Final Report of Structural Special Inspections

Project: *Renovations to 645 Congress Street*
Location: *645 Congress Street; Portland Maine*
Owner: *Bayside Maine, LLC*

Structural Design Professional in
Responsible Charge: *David A. Price, PE / Price Structural Engineers, Inc.*

Photo # 2 - Installation of Column at Grid F/5.8 (1st Floor)

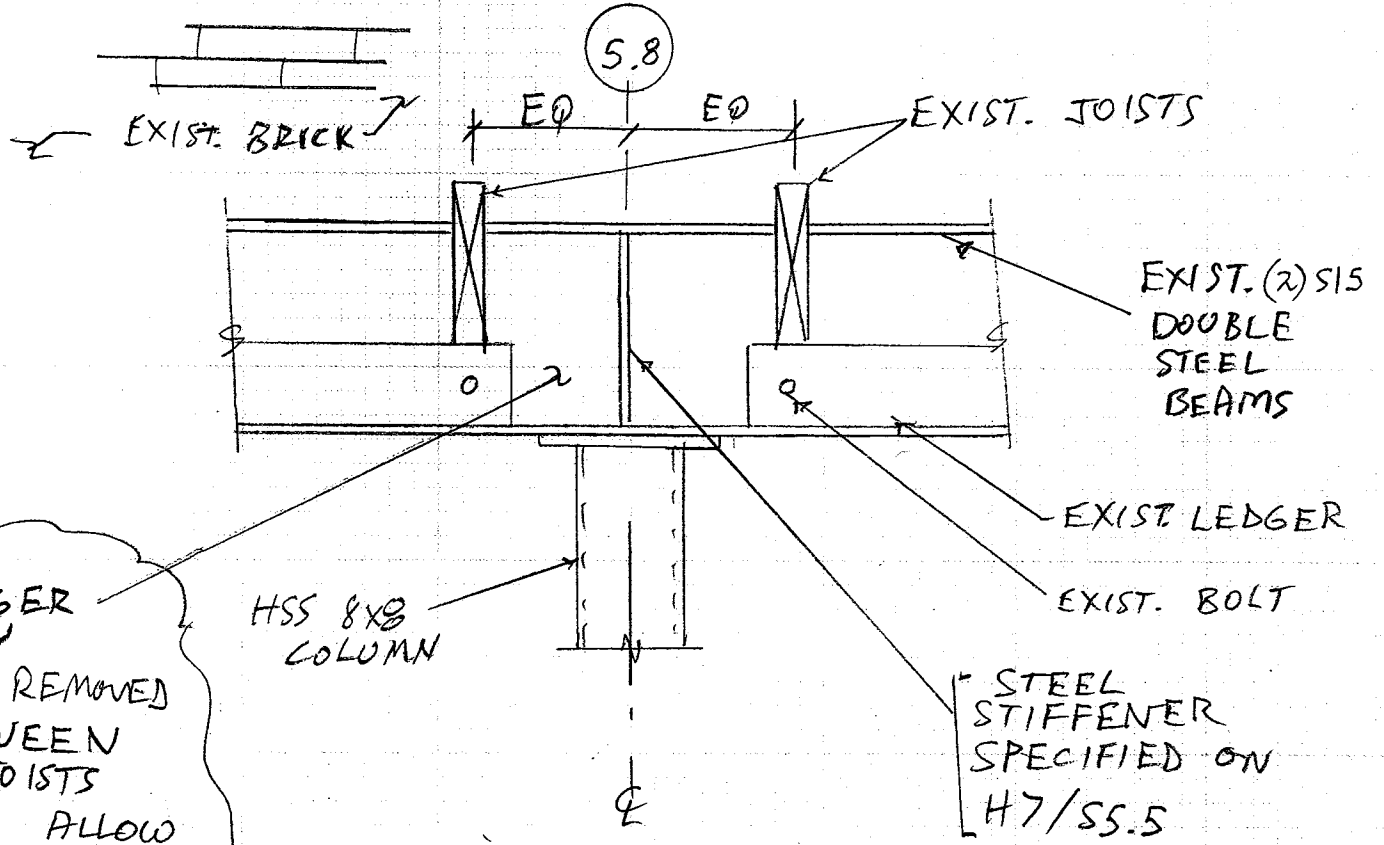
2. It can be seen that the new column at gridline F/5.8 does not have adequate bearing underneath, since there is a hole in the brick wall underneath the column (photo #2). This will need to be filled with solid masonry to provide adequate bearing (reference RFI # 11).

SK-S10 CLARIFICATION TO DETAIL G1/SS.4
NTS

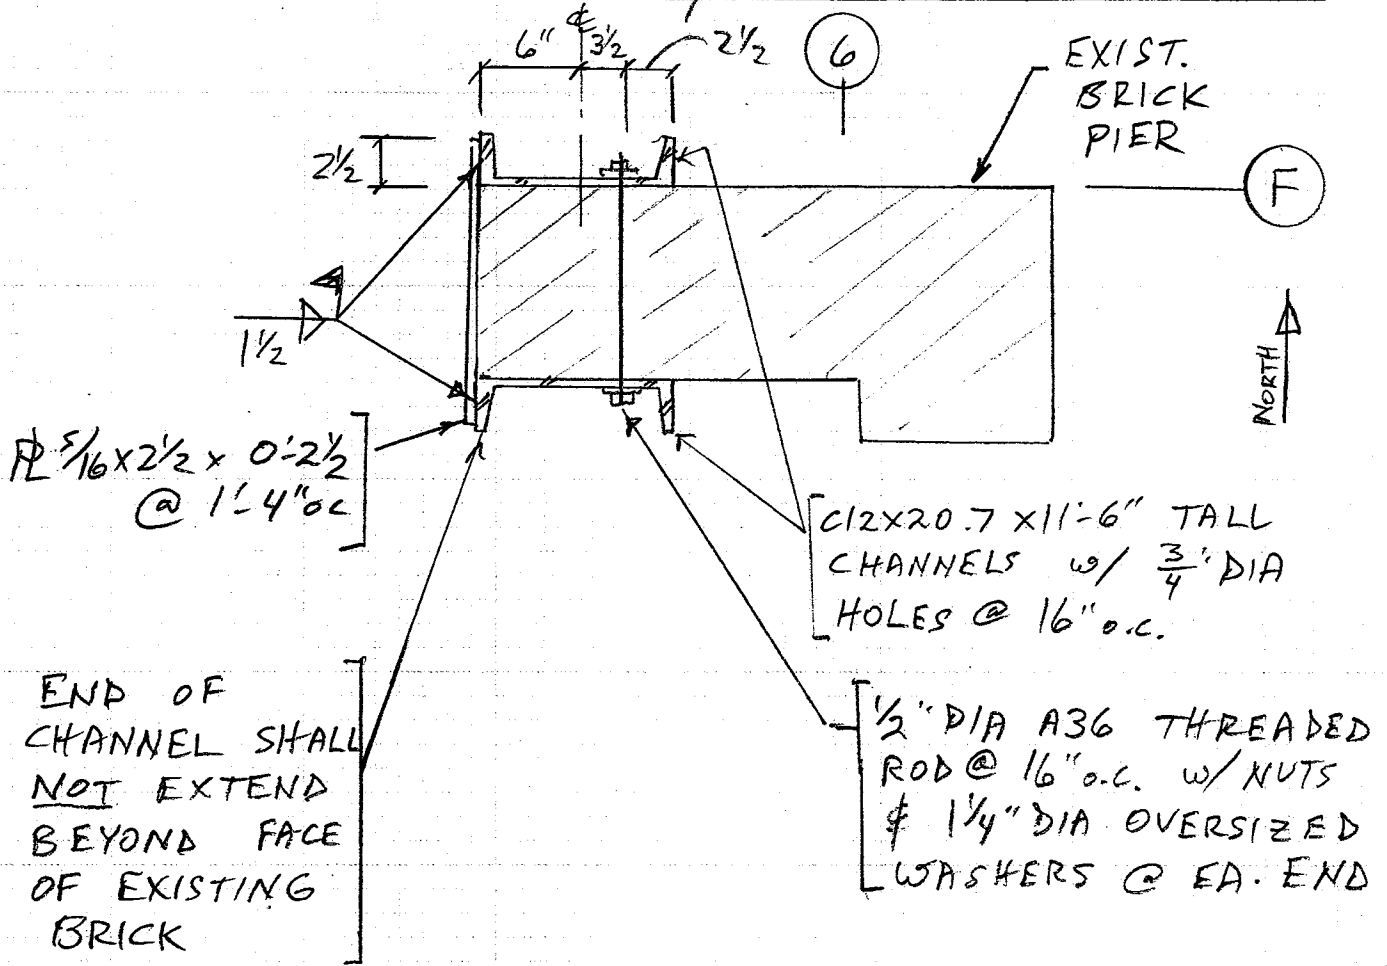
5. A new lintel is needed at Door Number 601-D (6th Floor). See attached photo #4 (Response to RFI #8 to follow).
6. Mark Hall was installing the column at F/5.8 and asked for clarification of how to install the stiffener on the south side of the steel beam due to interference with existing wood ledger (reference detail G1/S5.4). See attached detail SK-S10

LEDGER MAY BE REMOVED BETWEEN JOISTS TO ALLOW NEW STEEL STIFFENER

CORED PIPING SLEEVES @ EXISTING WALLS - LAYOUT PLAN
 - FIRST FLOOR PART PLAN
 NTS
 (Reference A1.01)

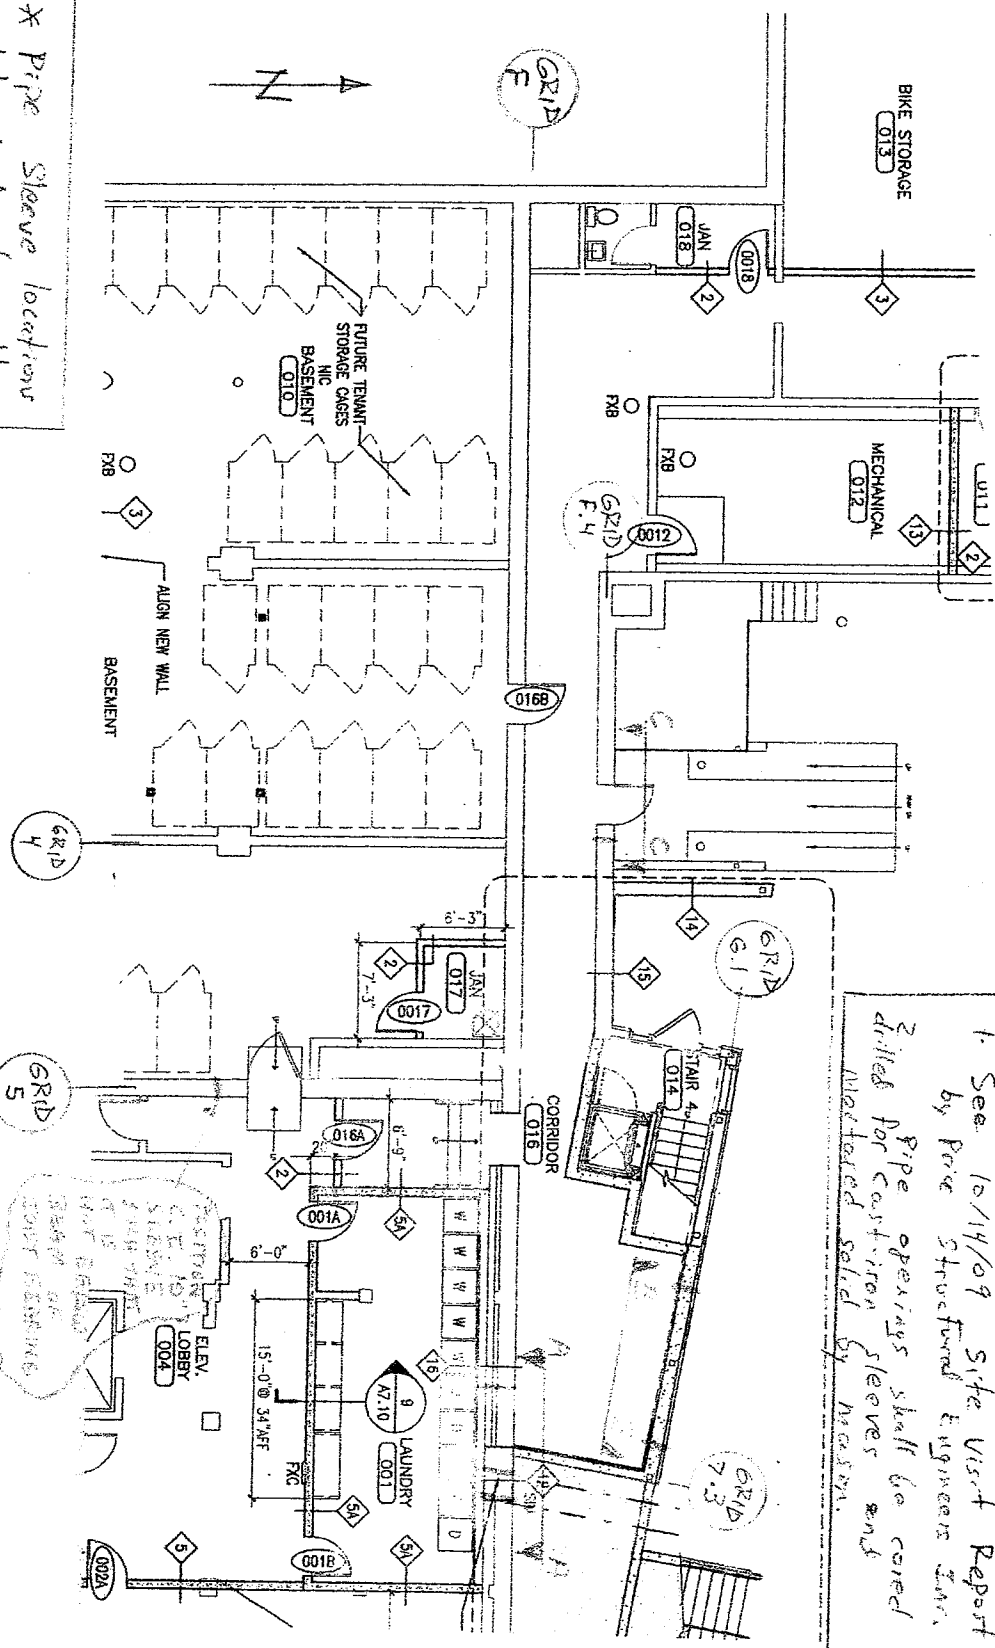
5. See attached "Cored Piping Sleeve – Layout Plan" and the corresponding elevations A, B, C that are attached with this report.
6. During the site visit it was also observed that the first floor steel beam located between grid E/2.5 to F/2.5 does not have adequate bearing at grid F/2.5 due to the presence of existing pipes underneath (see photo #4 in basement). The pipes are no longer needed so after temporary shoring is installed, the pipes must be removed and the masonry bearing repaired by the project mason. Other areas of the existing masonry wall on grid F basement wall between grids F/2 and F/3 also need to be repaired. Later, I mentioned the shoring concern to David Norton and Mark Leasure and it is my understanding that temporary shoring has now been provided.

FS REVISED SECTION
 1/2" = 1'-0"
 FS 53.3

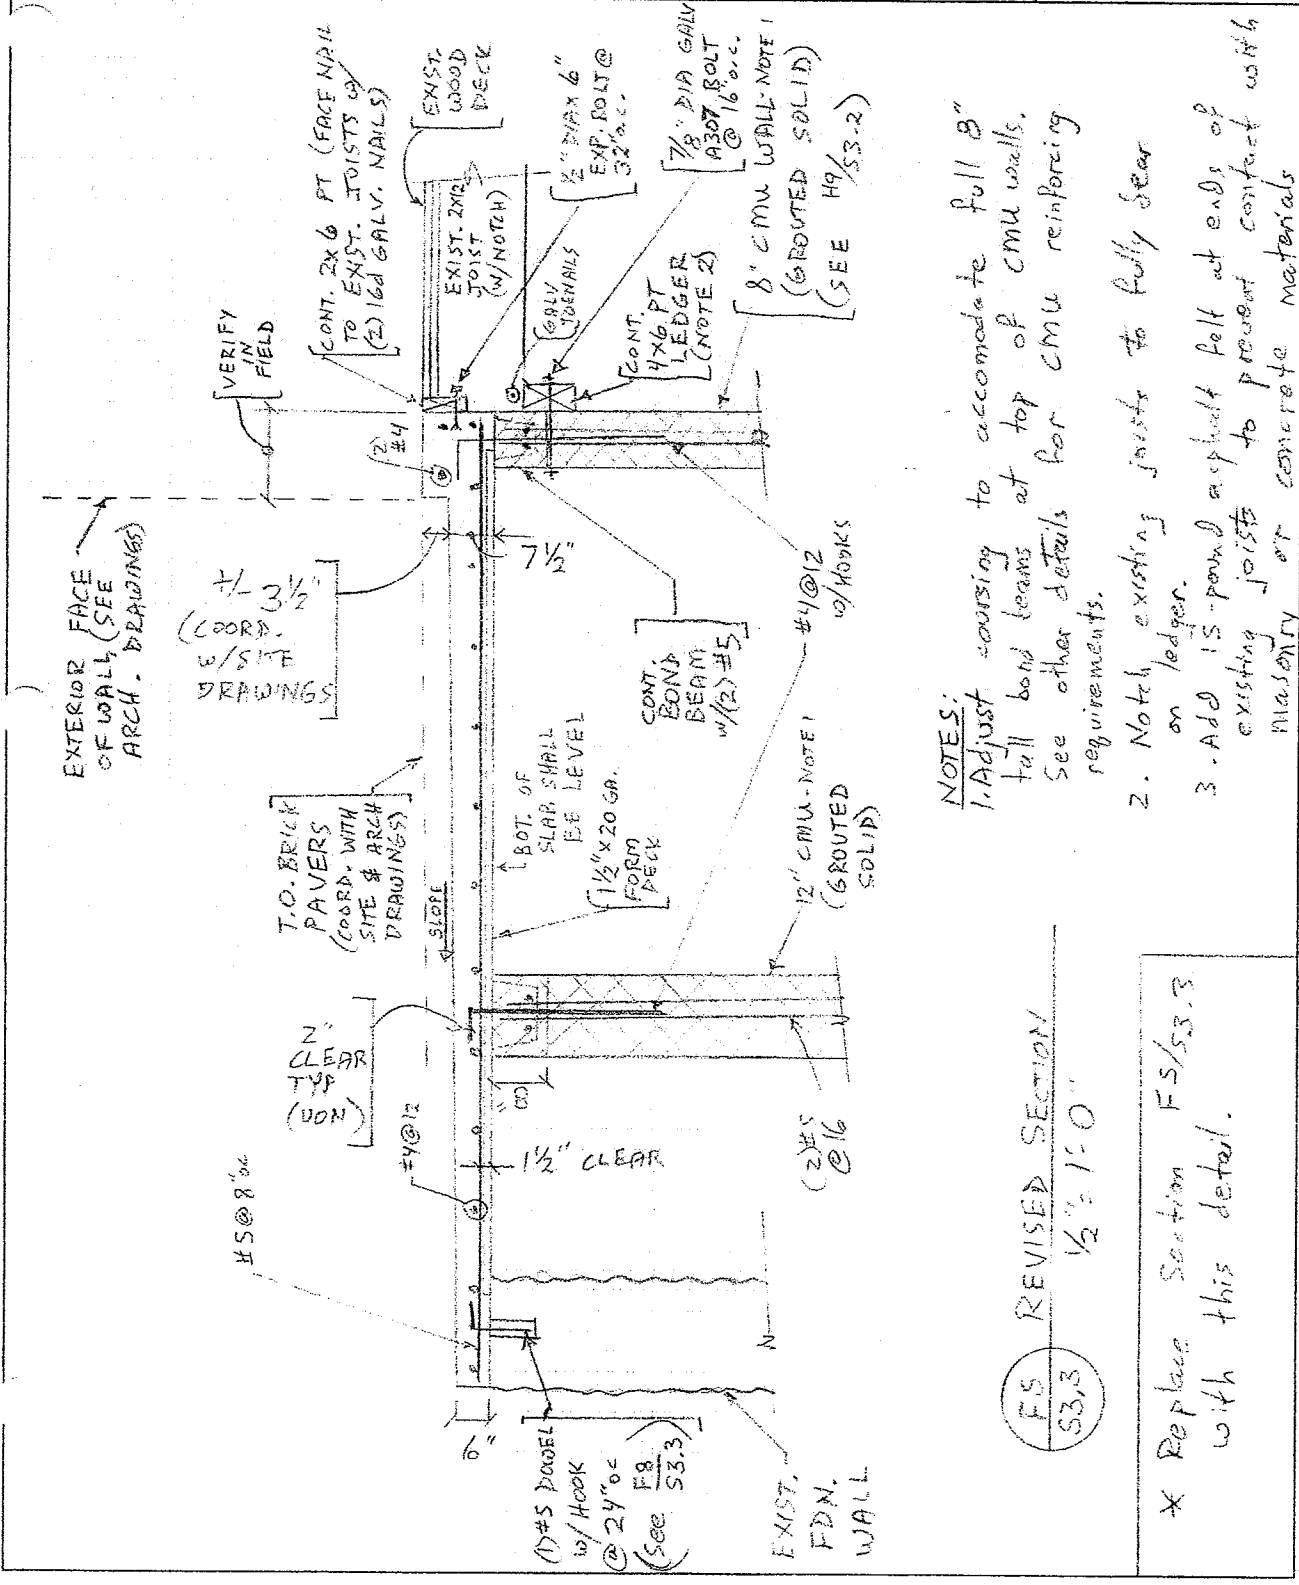
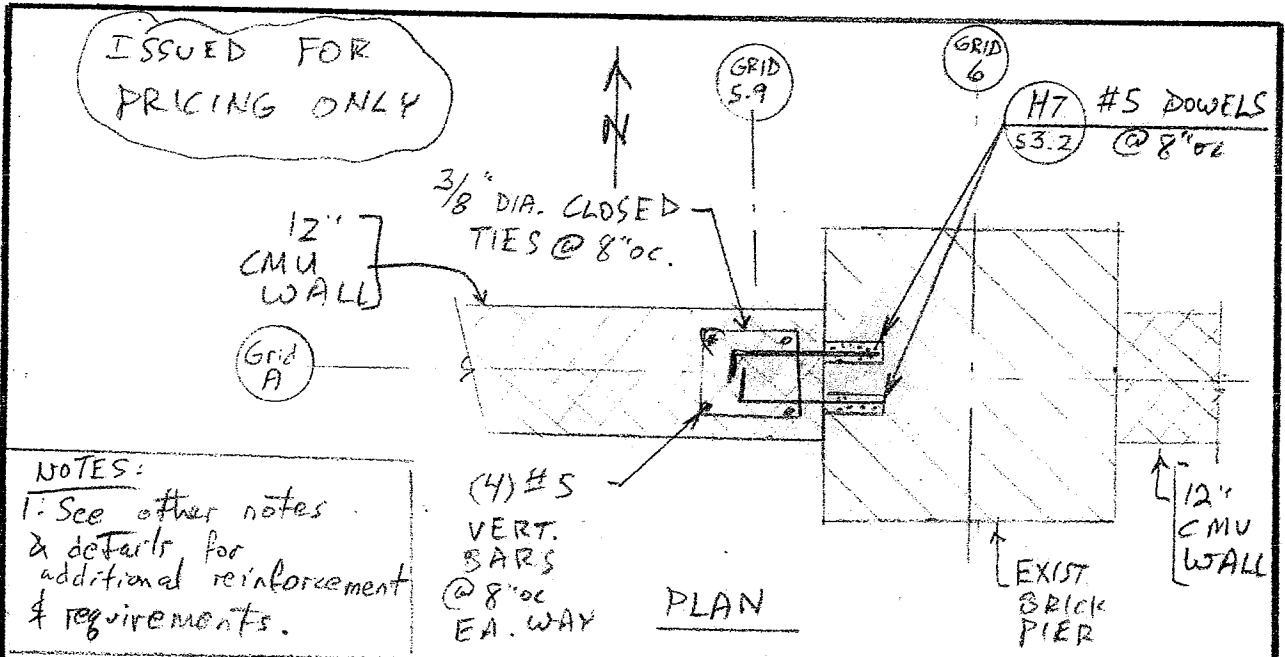
4. Construction at the main entrance first floor area was also discussed. See attached Revised Section F5/S3.3 which shows construction requirements at the main entrance (grid A/5.5) and interface with existing 12" joists. This Detail replaces the previous section F5/S3.3.

* Replace Section FS/53.3 with this detail.

REVISÉD ELEVATION @ GRID A (LOOKING SOUTH)
1"=1'-0"

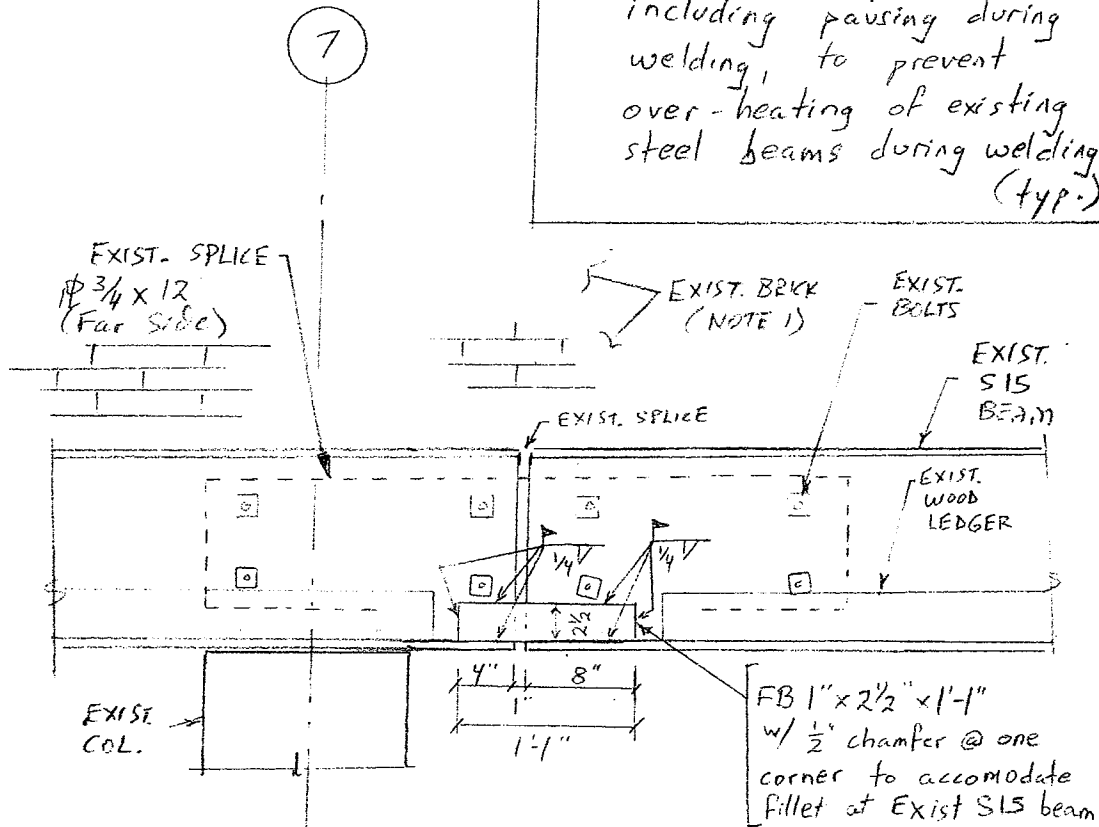
17. Install existing double beam splice at grid A/7 as specified in attached SK-S47-R (revised detail previously issued).
18. As an option (requested by contractor to facilitate construction), double beam splices may be installed in accordance with attached SK-S78 in lieu of previously specified detail H4/S5.5.

1. Provide temporary shoring (incl. in basement) during welding to existing beams (typ.).
2. Take necessary precautions, including pausing during welding, to prevent over-heating of existing steel beams during welding (typ.).
